CASCADE APARTMENTS

Early Design Guidance Meeting #2

400 Minor Avenue N
Seattle, WA 98109

HOLLAND PARTNERS & ANKROM MOISAN ARCHITECTS, INC.
DPD NUMBER: SITE A #3018928, SITE B #3018926

EDG RESPONSE - HARRISON GREEN STREET

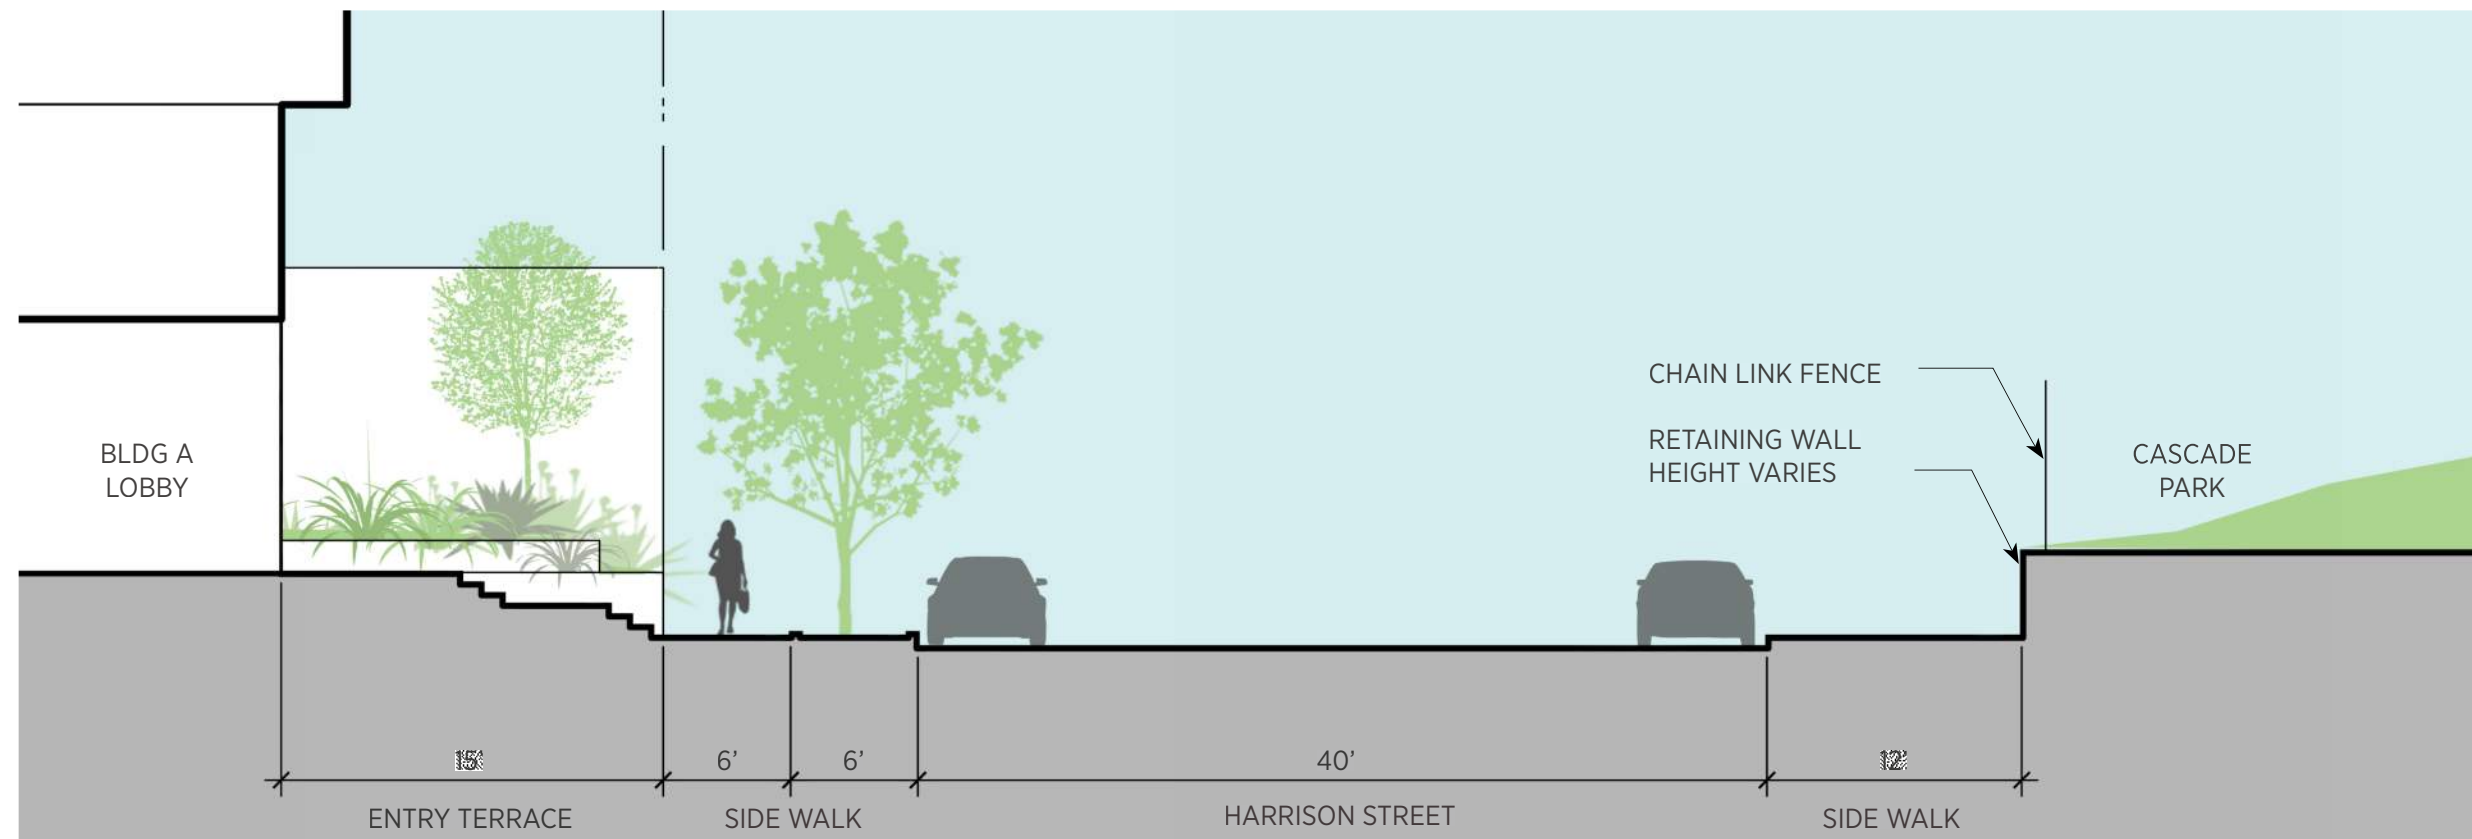
- *The Board noted the preferred design, which included ground level units that do not engage the street, was not appropriate facing the park. The Board felt the design was fortress-like, insular and opaque. The Board felt strongly that the ground level should be redesigned to function as an active porous transparent front porch to the park. (CS2-I, CS2-B, PL2-B3)*

- *The Board encouraged use of retail or other active residential accessory space to enliven the Harrison street level facade while providing a high degree of interaction with the pedestrian environment. (CS2-B, CS2-I, PL2-B, PL3-C)*

- *The Board directed the applicant to design the base to be porous, active and engage the public realm with a combination of indoor/outdoor spaces to reinforce the character of the park. (CS2-B, CS2-I, PL3-II, DC1-A)*

- *The Board was supportive of the intent to create visible, meaningful entrances with a relationship to the park, but questioned the location primary entries on the alley and aligned with the park path. The Board felt the entrances should relate to the context of the redesigned street facade facing the park. (CS2-B, PL3-II, DC1-A)*

There is a significant retaining wall along Cascade Park's northern edge. Our intent is to create an active zone slightly above street level, which will have a direct correlation with the park.

- All at grade residential units along Harrison have been eliminated in building A.
- Buildings A and B set back along Harrison providing a landscape amenity that mirrors the park edge.
- Apartment amenity space has replaced units at grade along Harrison.
- Building B entrance has been moved from the alley side to Harrison, to help activate the street.

EDG RESPONSE - MINOR

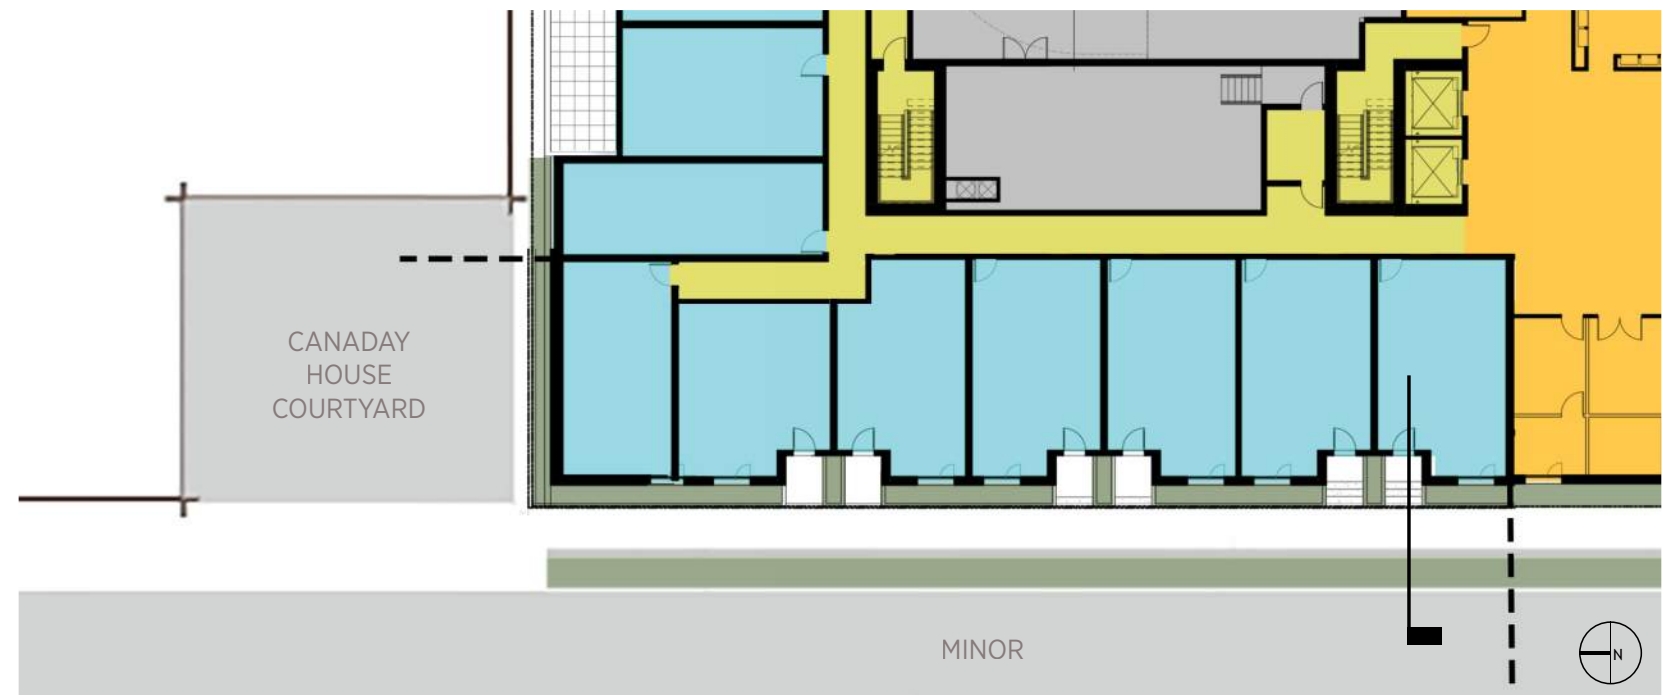
- *The Board agreed that the context of Minor and Pontius are appropriate for ground level residential units. The Board directed the applicant to provide a buffer between the unit and the sidewalk. The buffer should provide a feeling of shelter and protection for units from the sidewalk. The buffer may include landscaping and/or stoops. (PL3-B, PL3-III)*
- *Design the scale and texture of the ground level to provided a positive pedestrian experience. (DC2-D)*
- *The Board agreed below grade units facing the sidewalk are not appropriate for the urban neighborhood. (PL3-B)*

Response: All units more than 18" below grade have been removed. Stoops have been added to the units for direct access from grade. The entire facade of street level units has been set back 3' from the property line. Entry doors are 7' back from the property line. A generous planter has been included.

EDG RESPONSE - FINER GRAIN ANALYSIS - STACKHOUSE

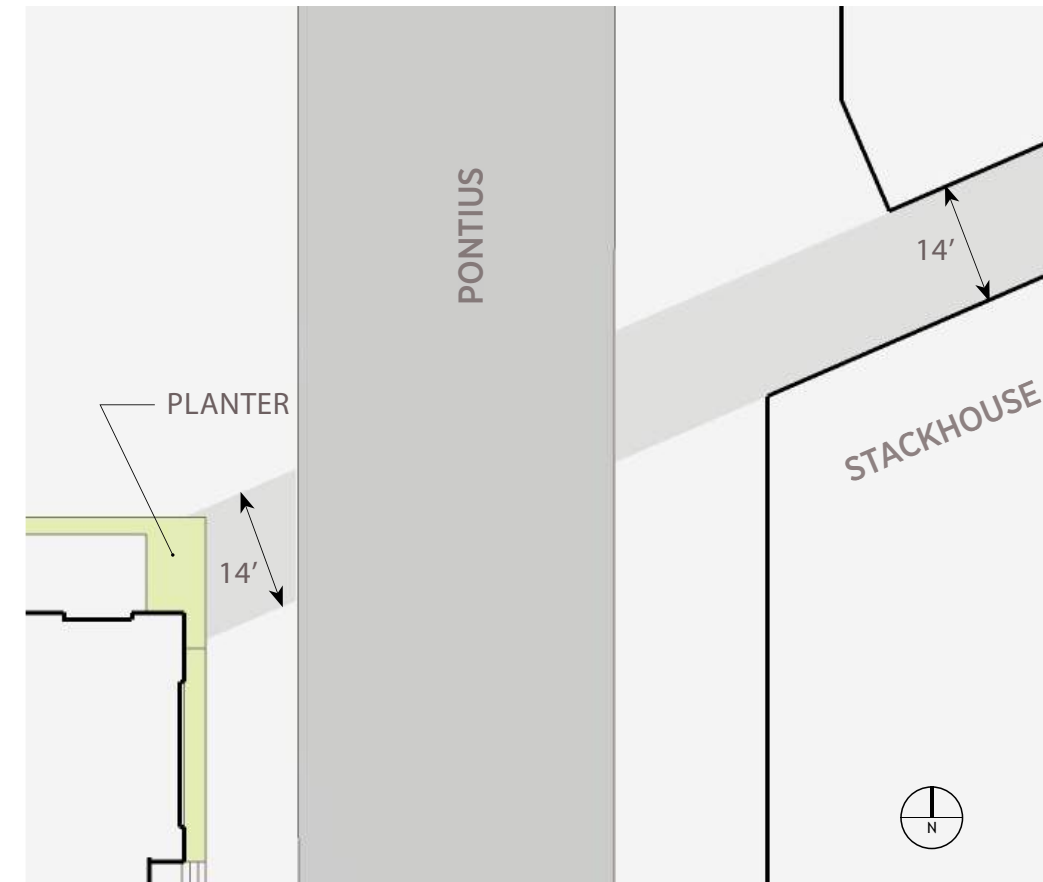
- *The Board requested additional analysis of the massing and site design and demonstration of how the design includes a relationship to the adjacent context.*
- *At the second Early Design Meeting, the board would like to see more information on the treatment of the north facade in relationship to existing building and courtyard. (CS2-D5)*
- *The Board required additional detail showing how the building responds to the Stack House entry at the street. (PL1-A)*

EDG RESPONSE - FINER GRAIN ANALYSIS - ALLEY

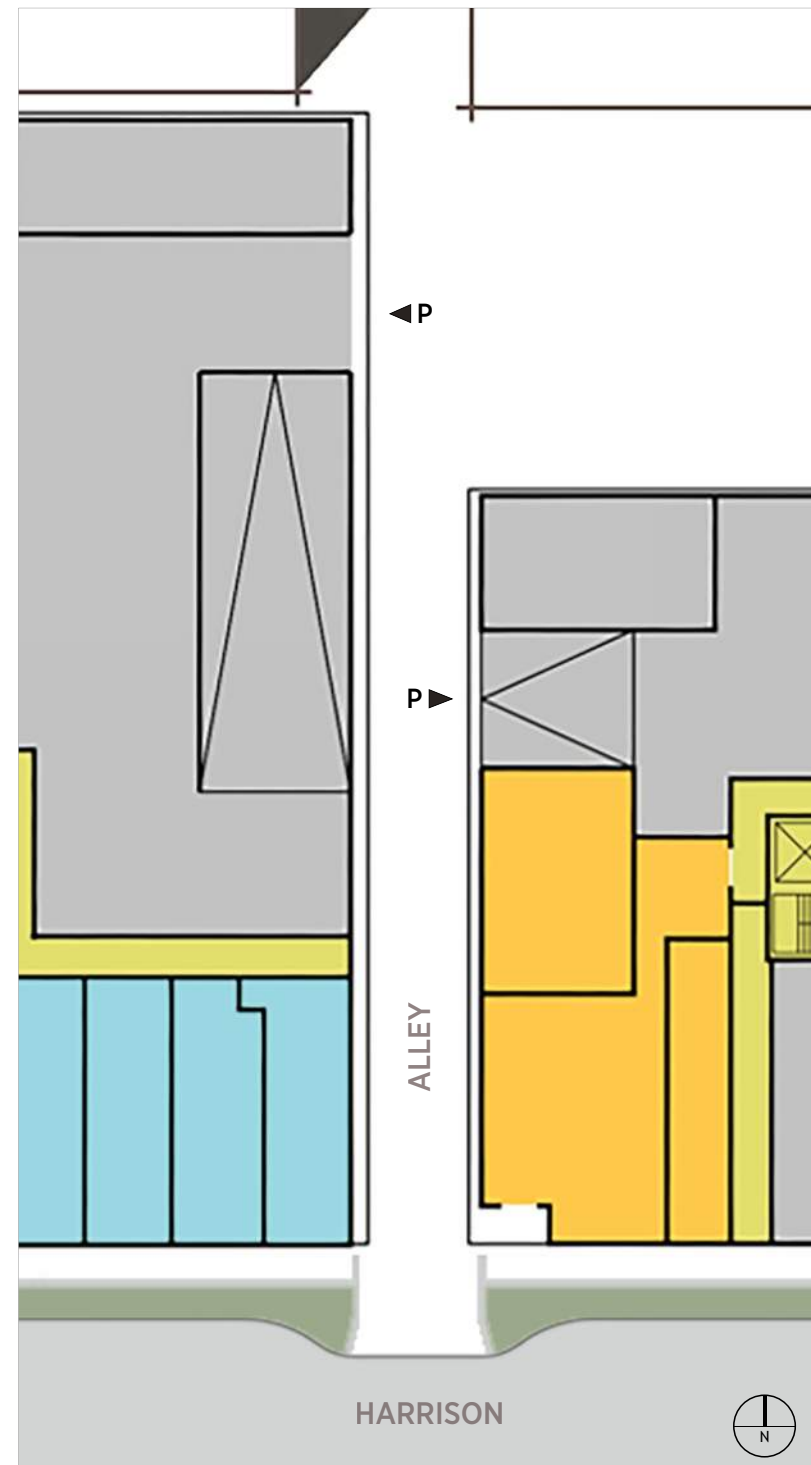
The Board felt the alley was not properly activated.

Units have been added to the alley to help promote a substantial pedestrian experience. Units will be buffered by generous planting and a low wall.

At building A units have been removed to place a shared fitness center at the corner of Harrison and the alley.

EDG RESPONSE - REQUESTED DEPARTURES

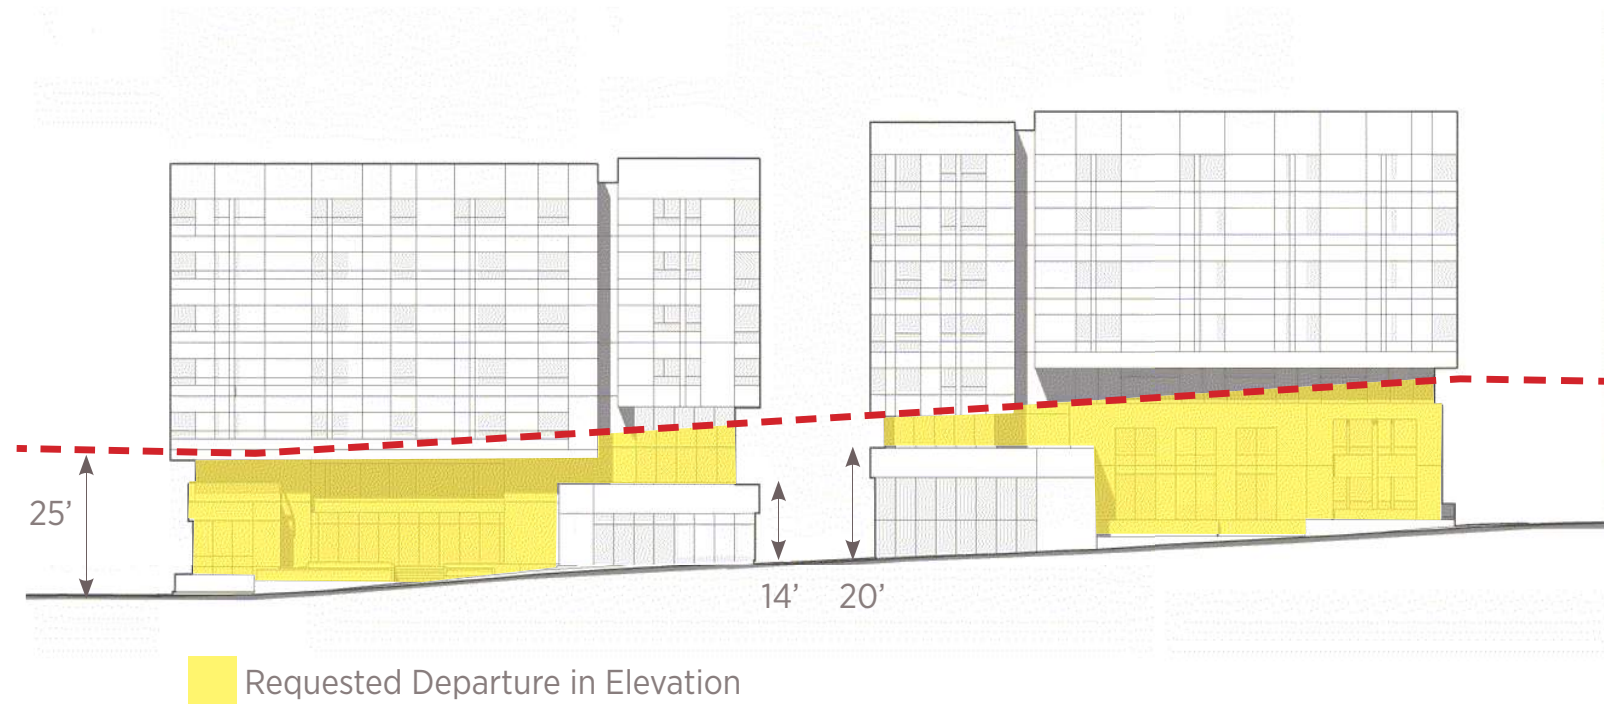
“The Board noted that the required changes to the ground level facade on Harrison Street would likely require a loss of volume at the street. The Board expressed early support for a departure to the upper level setback along the alley in order to meet the direction for the design of the facade facing the street.”

A Facade height departure is requested along Harrison, to help open up the base of the building, provide a generous landscape buffer, and to enhance the pedestrian experience at grade.
